Access Compliance Report

Public Rights-of-Way

(Curb Ramps)

Intersection ID: 46144	Main Street: EASTFIELD_VILLAGE_LN	Cross Street: ROCKY_FORD_CLUB_RD	Location: E
ADA ID: 6E477A5BDC03	Ramp Type: Perp	Initial Pass/Fail: Fail	Overall Compliance: No
Severity Score: 36.25			
Codes/Mitigation Info/Possible Solution		Field Measurements/Component Compliance

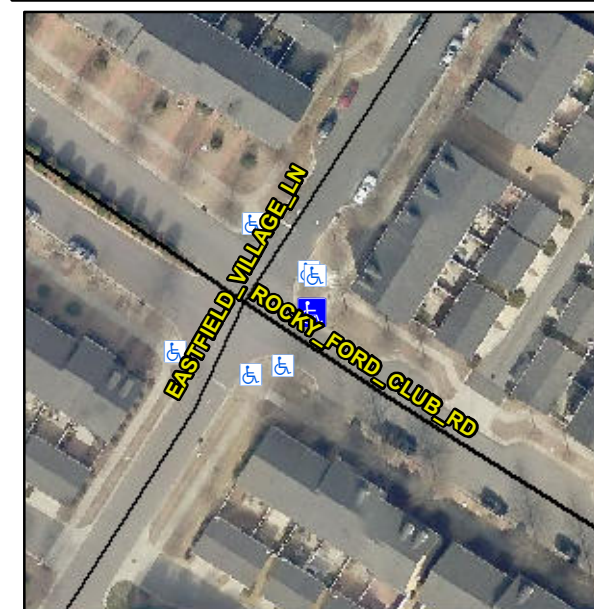
R304.5.1, R304.5.3

Compliance	Description	Data	Compliance	Description	Data
N/A	Ramp Length (in)	198.0	Yes	Ramp Slope (%)	7.2
No	Ramp Width (in)	25.0	No	Ramp XSlope (%)	4.7
N/A	Flare Type LT	N/A	N/A	Flare Type RT	N/A
N/A	Flare Slope LT (%)	N/A	N/A	Flare Slope RT (%)	N/A
N/A	Flare Traversable LT?	N/A	N/A	Flare Traversable RT?	N/A
N/A	Landing Length (in)	N/A	N/A	DWS Provided?	N/A
N/A	Landing Width (in)	N/A	N/A	DWS Contrast?	N/A
N/A	Landing Slope (%)	N/A	N/A	DWS Length (in)	N/A
N/A	Landing X Slope (%)	N/A	N/A	DWS Full Width?	N/A
N/A	Landing Curb? (Y/N)	N/A	N/A	DWS Offset (in)	N/A
N/A	Shared Landing?	N/A			
N/A	Gutter Ponding?	N/A	N/A	Gutter Slope (%)	N/A
N/A	Gutter Lip Ht (in)	N/A	N/A	Gutter X Slope (%)	N/A
N/A	Painted X Walk1?	No	N/A	Painted X Walk2?	N/A
	X Walk 1 Direction	To SW		X Walk 2 Direction	N/A
N/A	X Walk 1 Width (in)	N/A	N/A	X Walk 2 Width (in)	N/A
	X Walk 1 Slope (%)	4.5		X Walk 2 Slope (%)	N/A
	X Walk 1 X Slope (%)	3.6		X Walk 2 X Slope (%)	N/A

Remove & Replace Entire Ramp.
